Groundwater Application Review Summary Form

Application # G- 19442

PUBLIC INTEREST REVIEW FOR GROUNDWATER APPLICATIONS

TO: Water Rights Section Date 11/22/2024
FROM: Groundwater Section James Hootsmans
Reviewer's Name
SUBJECT: Application G- 19442 Supersedes review of _____
Date of Review(s)

Water-Level Measurements in Nearby Wells

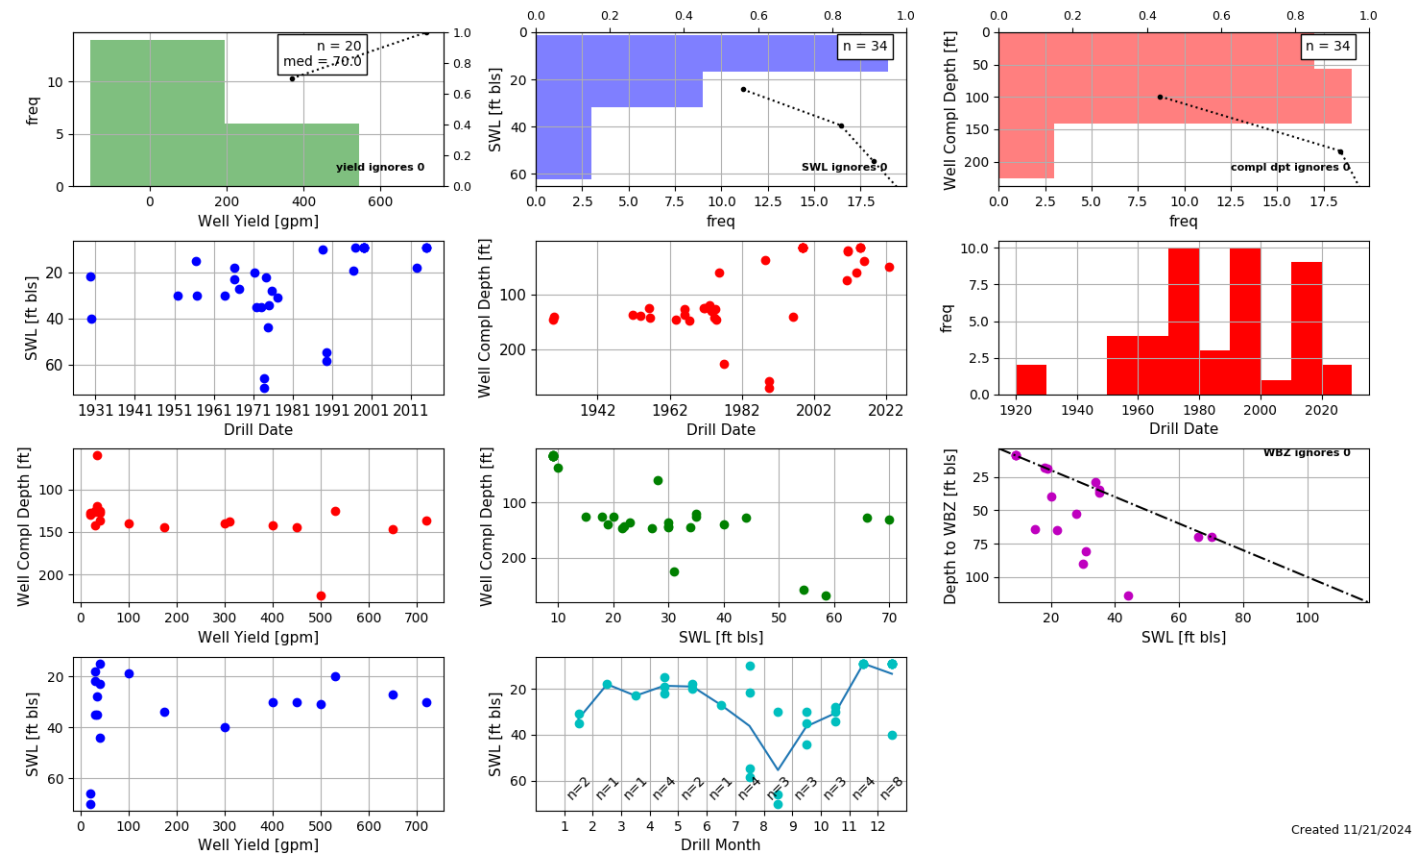
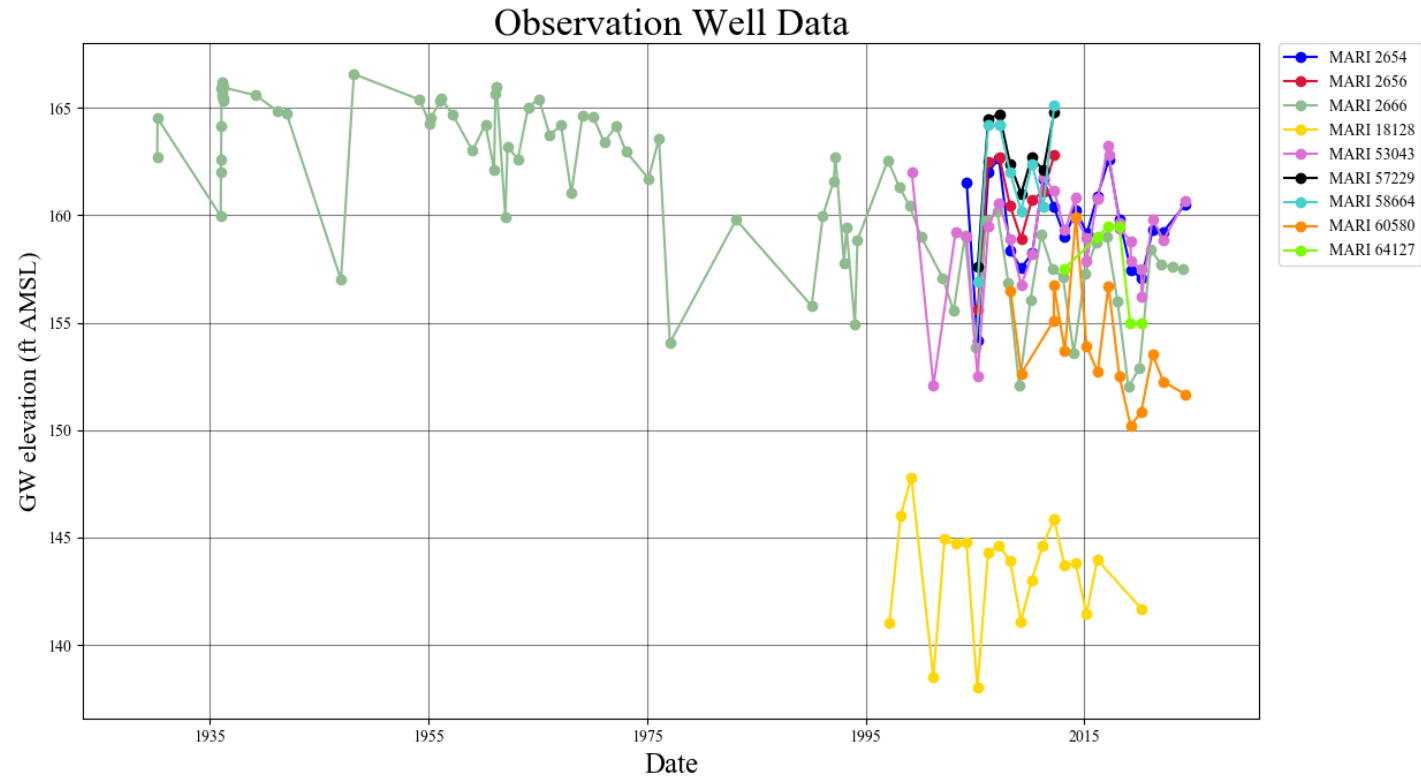
Recent water levels for nearby observation wells do not indicate persistent or widespread declines in the Willamette Aquifer in this area (see Hydrograph, attached). Specifically, water levels in state observation well MARI 2666 have declined approximately 8 feet in the last 80 years. Other wells with shorter periods of observation show no obvious declines. Because of uncertainties about the stability of the resource, annual water levels measurements are recommended (permit condition 7RLN) to assess the health of the ground-water system over time.

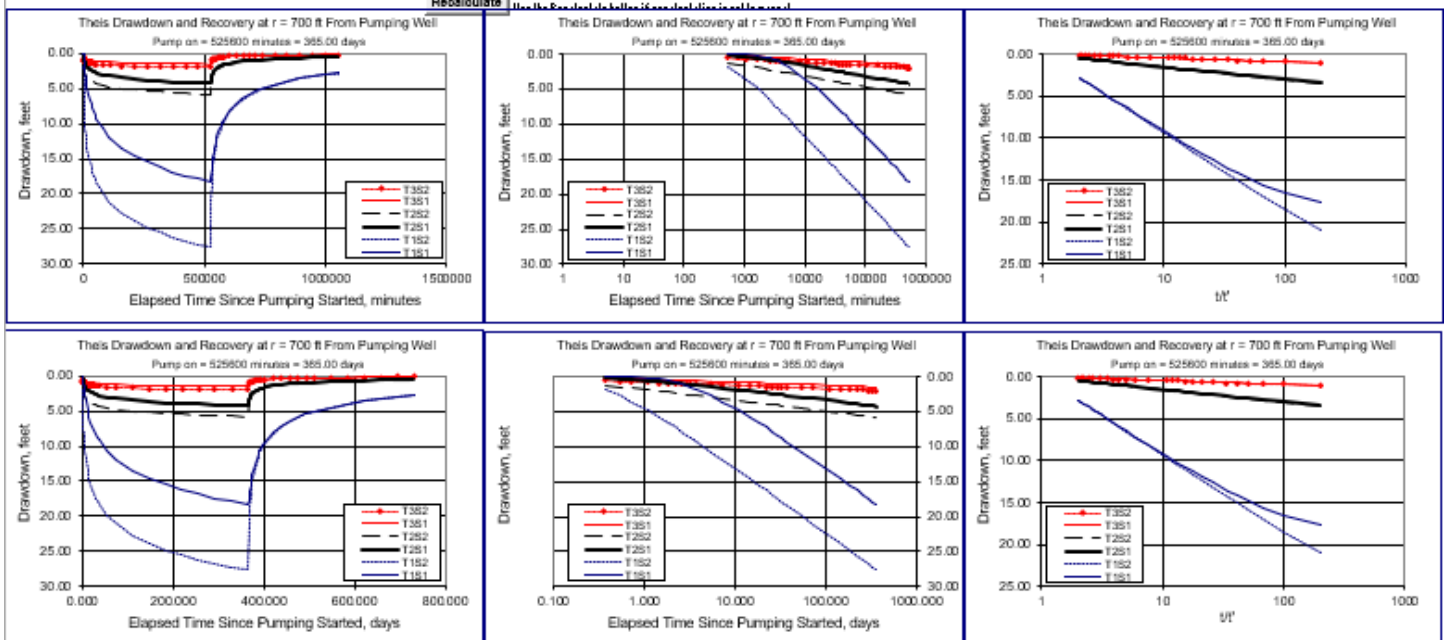
Potential injury to other nearby groundwater rights was analyzed using the Theis equation for drawdown in a confined aquifer (Theis, 1935). Hydraulic parameters used for the analysis were derived from regional data and studies (Pumping Test Reports, Conlon et al., 2003, 2005; Iverson, 2002; McFarland and Morgan, 1996; Woodward et al., 1998) or are within a typical range of values for the parameter within the hydrogeologic regime (Freeze and Cherry, 1979; Domenico and Mifflin, 1965). The nearest known groundwater right to the proposed POA is MARI 2671, approximately 700 ft southwest of POA 2 (PROP 561) (see Well Location Map, attached). Assuming a continuous pumping rate of 0.38 cfs (~143 gpm) year round under the most likely hydraulic parameters, results using the Theis equation indicate that pumping of PROP 561 is not anticipated to affect another groundwater right such that said right would not be able to divert water to which it is legally entitled (see Theis Drawdown Analysis, attached).
